Urgent Field Safety Notice

Subject: Liko® Viking® L, Viking® M, Viking® XL, and Viking® 300 Mobile Lifts – Potential Actuator Damage

FSCA-identifier: Mod 1228

Type of action: Corrective Action Notification

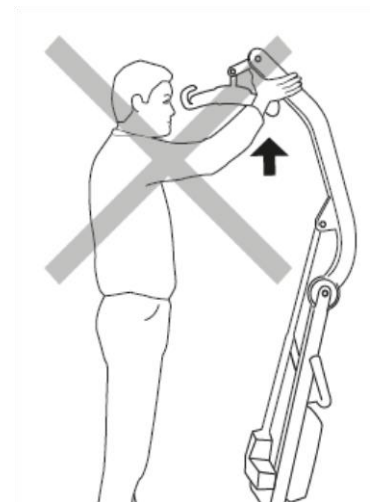
This issue is preceded by users who lift the lift arm assembly manually, as shown in the illustration to the right.

The lift arm assembly is intended to only be lifted by the actuator (lift motor). If the lift arm assembly is manually lifted, the actuator can become damaged and get stuck in the highest position. When the actuator is stuck, the lift cannot be raised/lowered by the lift motor. If a patient is lifted into the sling while the actuator is stuck, there is a potential risk of a free fall of the patient. This hazard could cause minor or potentially catastrophic injuries to a patient if the free fall encompasses the entire stroke of the actuator.

Hill-Rom requests customers not to raise the lift arm manually since the lifting actuator can become stuck and/or become damaged. Always use the hand controls or the control box to operate the lift. There are no hazards when using the device as intended. Hill-Rom is updating the product labelling to address this hazard.
